Date of Issue: April 2015, API Monogram Program Effective Date: October 9, 2015

Affected Publication: API Specification 20A, *Carbon Steel, Alloy Steel, Stainless Steel, and Nickel Base Alloy Castings for Use in the Petroleum and Natural Gas Industry*, First Edition, March 2012

ADDENDUM 2

Figure—6 Photomicrograph Locations

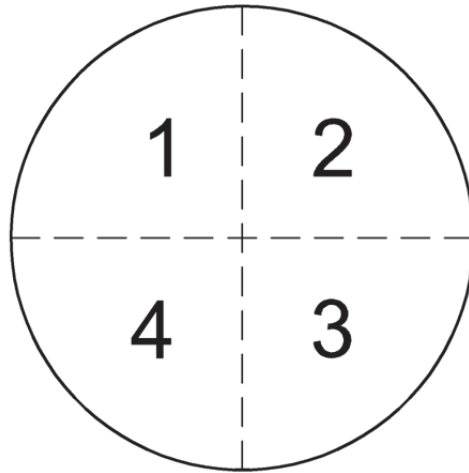
4.4.7.4 For Group A, Group B, and Group C materials, steel cleanliness shall be determined in accordance with ASTM E45 using the sample from 4.4.7.2 and reported as shown in Table 4. Four (4) photomicrographs shall be taken at 100X magnification. A photomicrograph shall be taken of a representative field in each of the four quadrants shown in Figure 6. Results shall be documented as informational only.

Page 11, **Figure 6** shall be added:
